# ABINGTON TOWNSHIP

## PLANNING COMMISSION MEETING

- a. Review LD-25-03 Noble Town Center South Parking Improvements - Preliminary/Final Land Development Plans.
- b. Discuss an Ordinance of Abington Township, Montgomery County, Pennsylvania, pursuant to Article V of the Pennsylvania Municipalities Planning Code amending the Abington Township Subdivision and Land Development Ordinance of 1991 to amend Section 146-51 to permit a waiver from the Land Development Plan approval process for a partial nonconforming structure restoration.

Review LD-25-03 Noble Town Center South Parking Improvements - Preliminary/Final Land Development Plans.

CB-3 TO EXISTING MANHOLE PROFILE

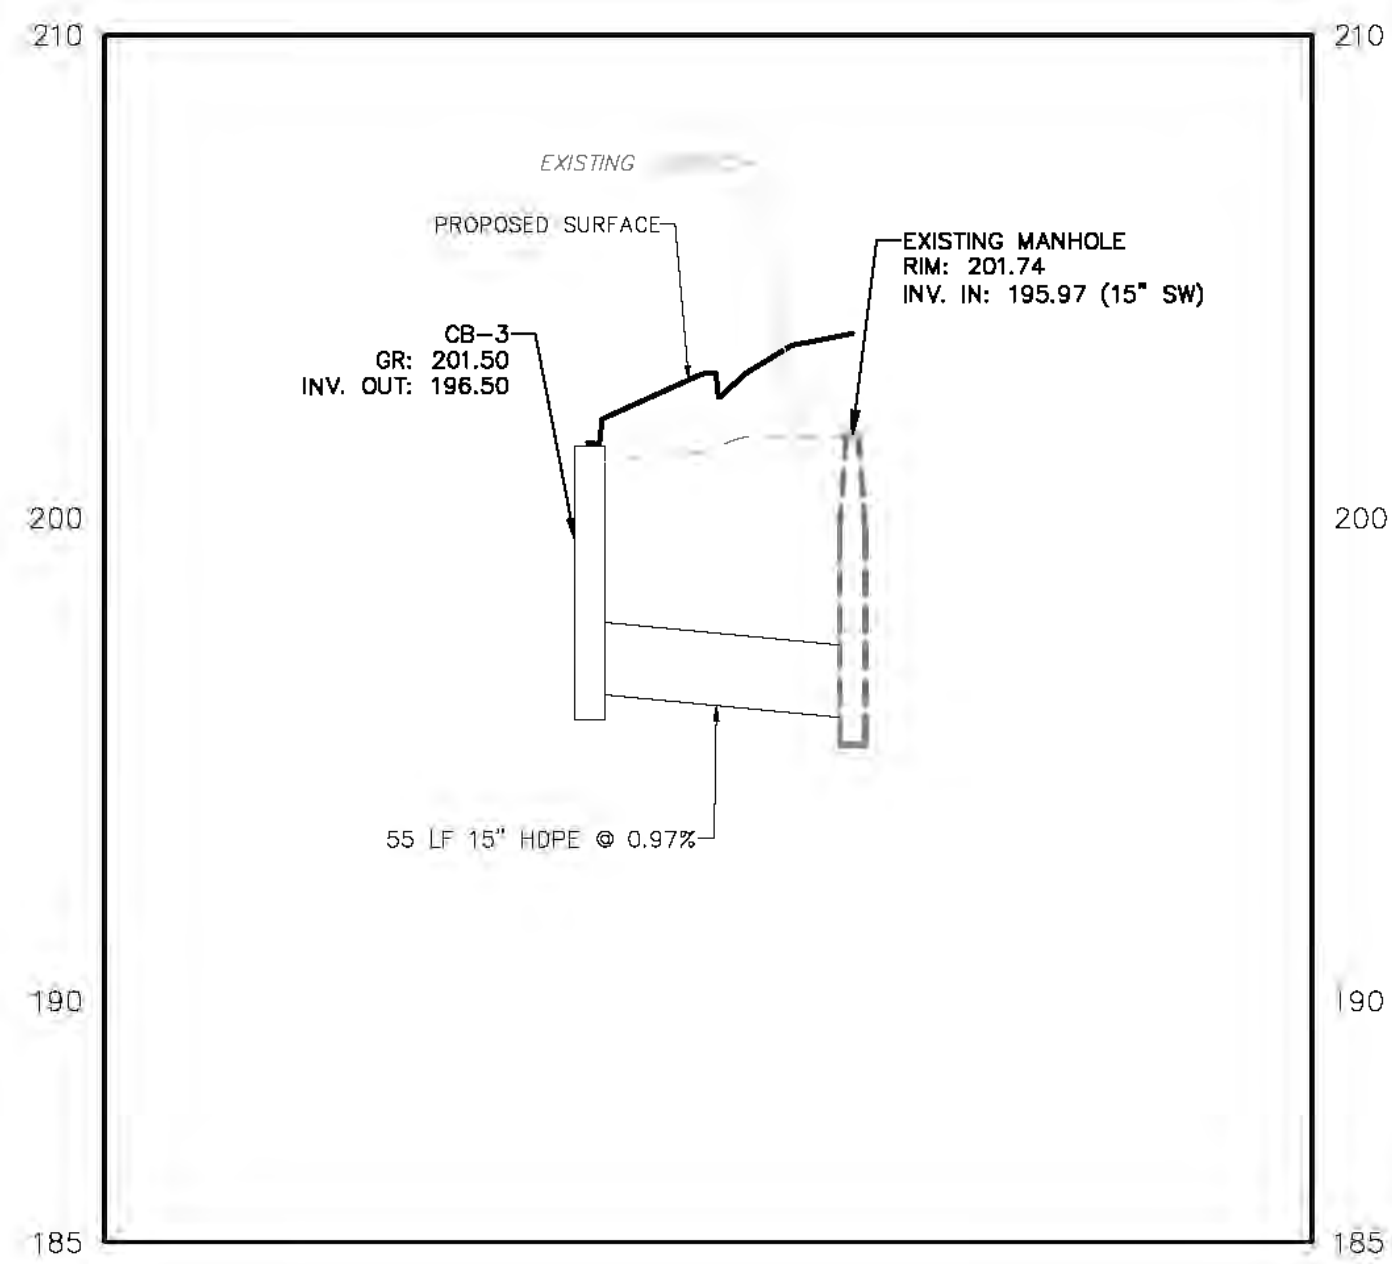
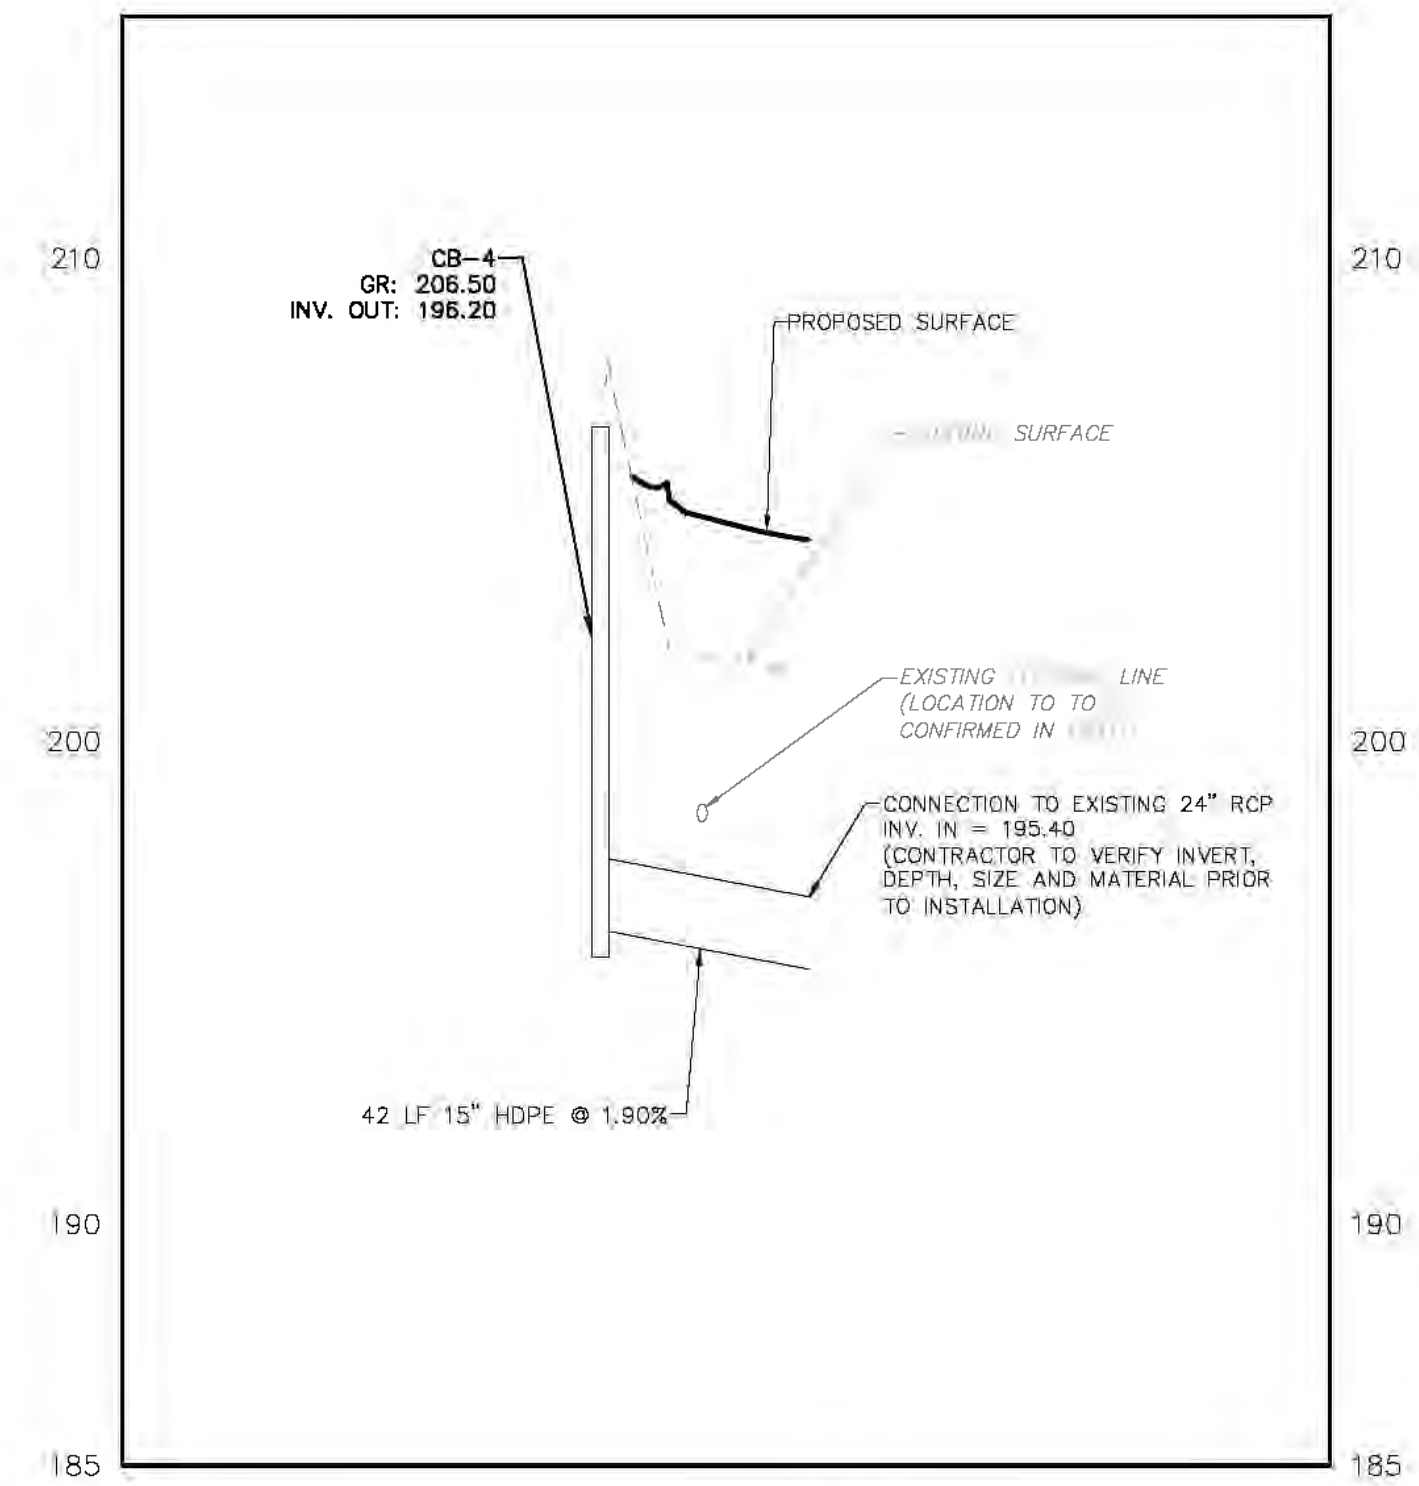
45. The Applicant is proposing two new inlets (CB-3 & CB-4) that are shown to connect to the existing stormwater piping on site and not connecting to the proposed infiltration basin. It is recommended that these inlets be tied into the proposed infiltration basin to allow the stormwater to be captured and treated.
46. On the Storm Sewer Profiles Plan (Sheet 10) a scale for the profiles is not provided. The vertical and horizontal scales shall be confirmed and included on the plan.

Abington Twp Comments - Sanitary Sewer

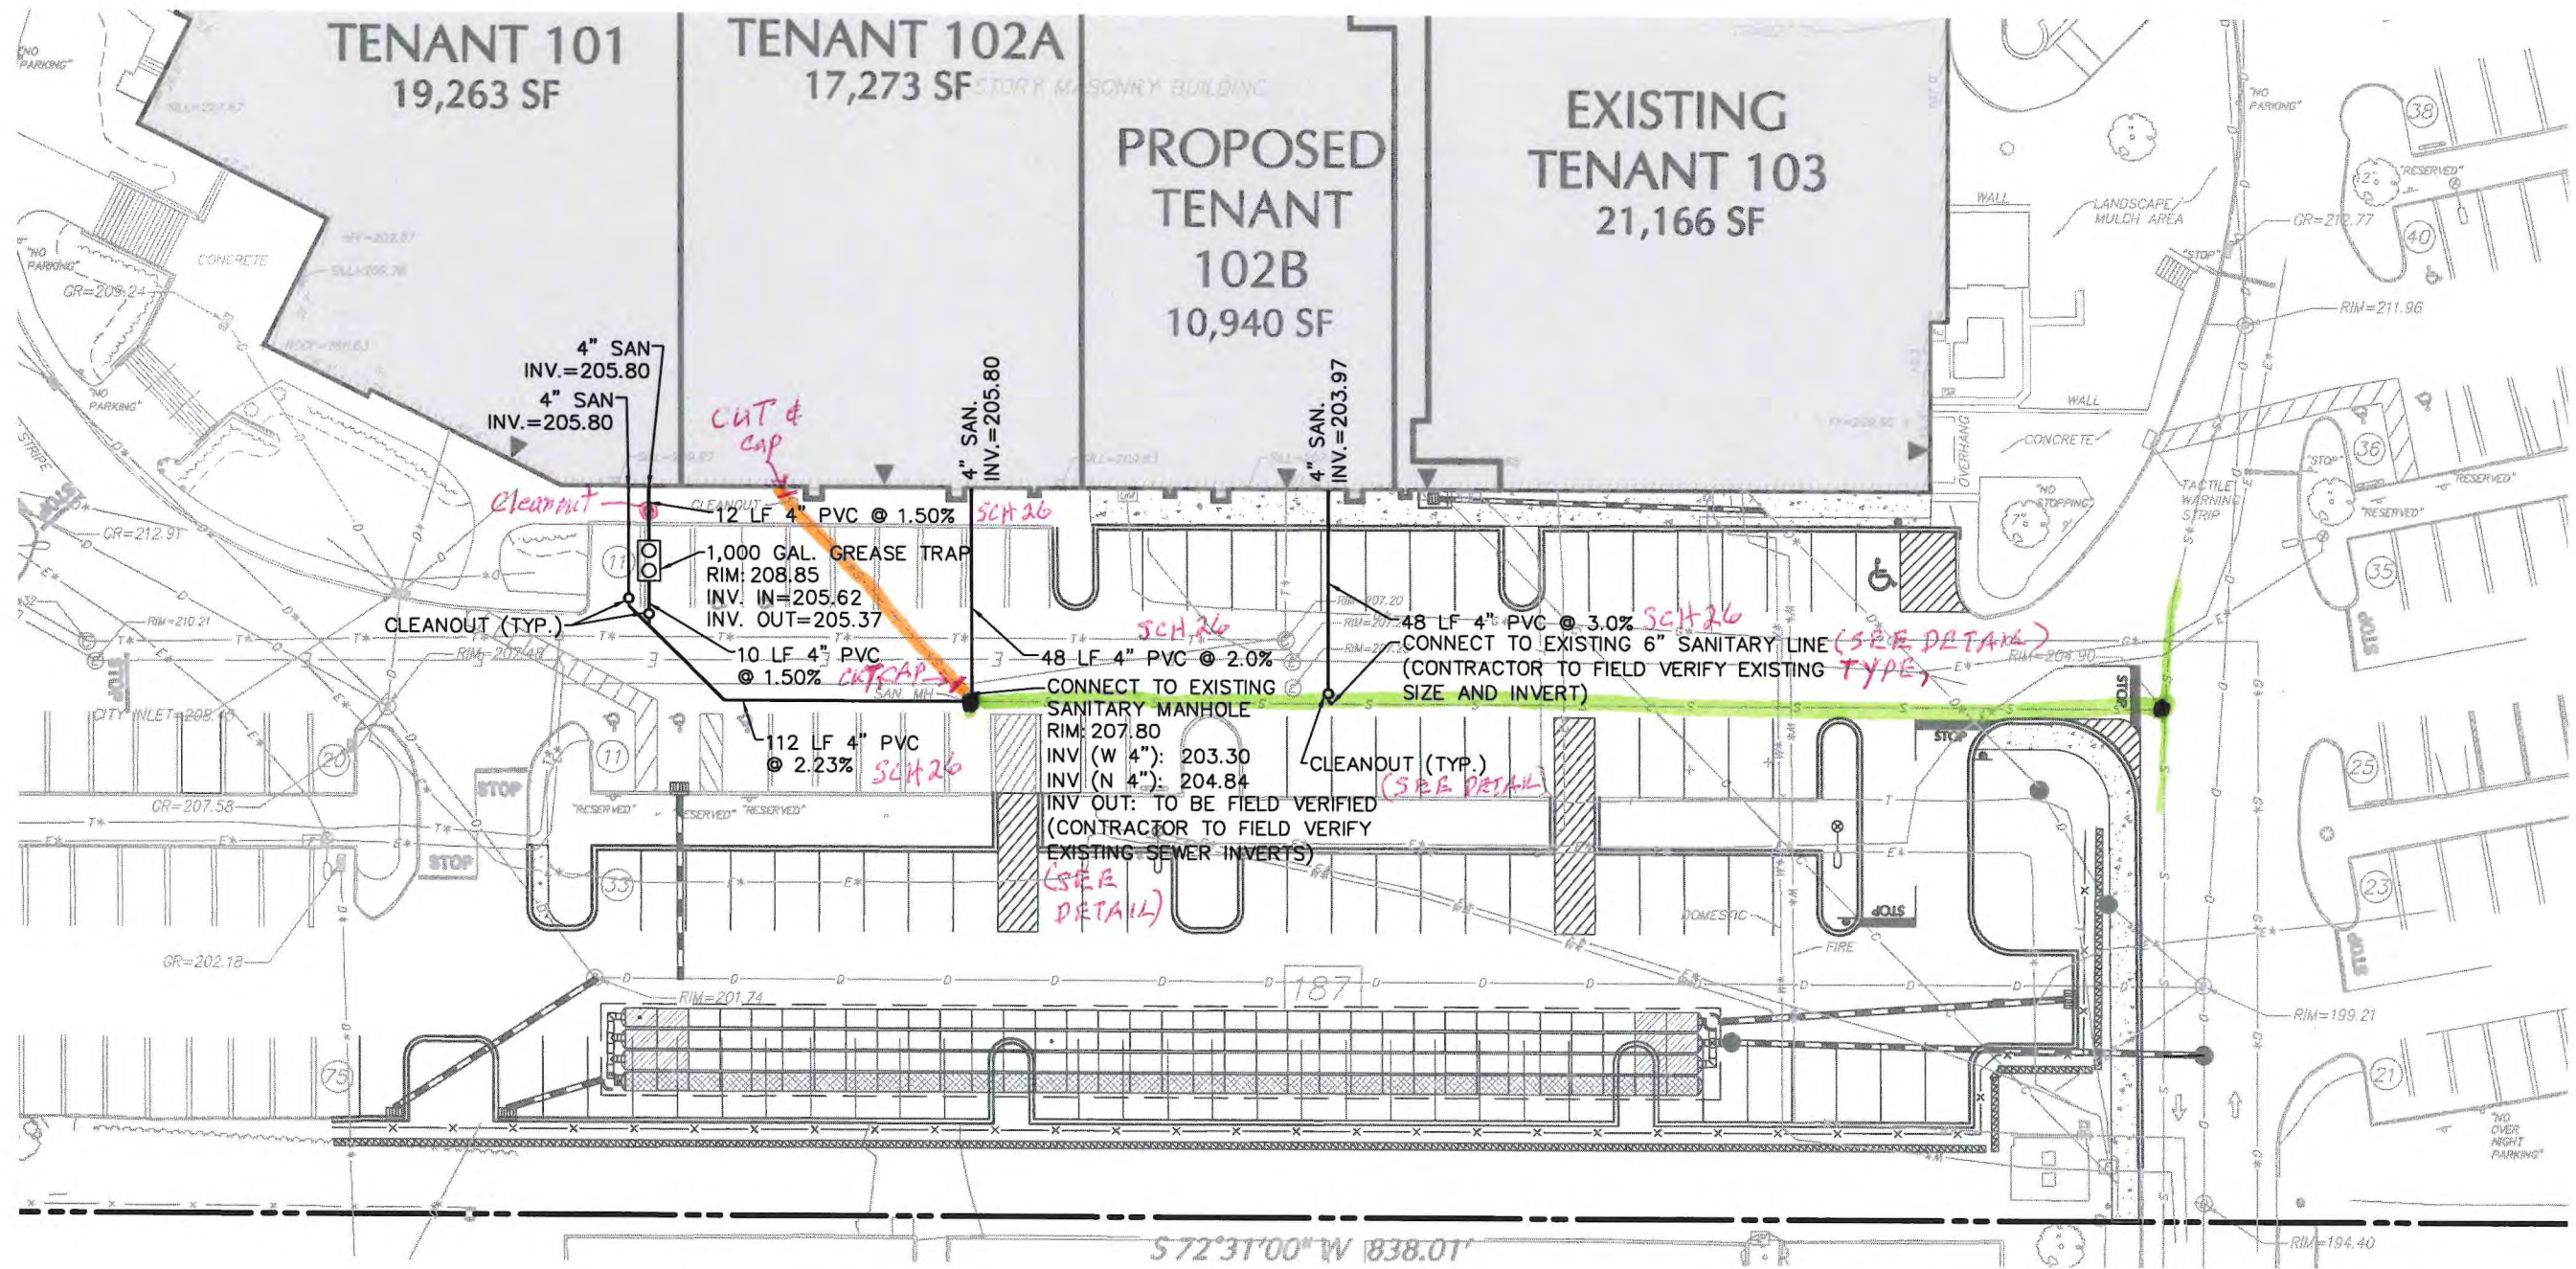
Utility Plan CU-101 (Sheet 17 of 18):

1. Labels should be added to the plan sheet to indicate the type of existing pipe, references to details and various pipe materials and construction requirements. See the attached marked up Sheet 17 of 18 for specific requirements.
2. The existing sanitary sewer pipe and cleanout shall be cut and capped adjacent to the building and at the existing manhole.
3. Calculations to size the proposed grease trap should be submitted and a detail provided within the plans.
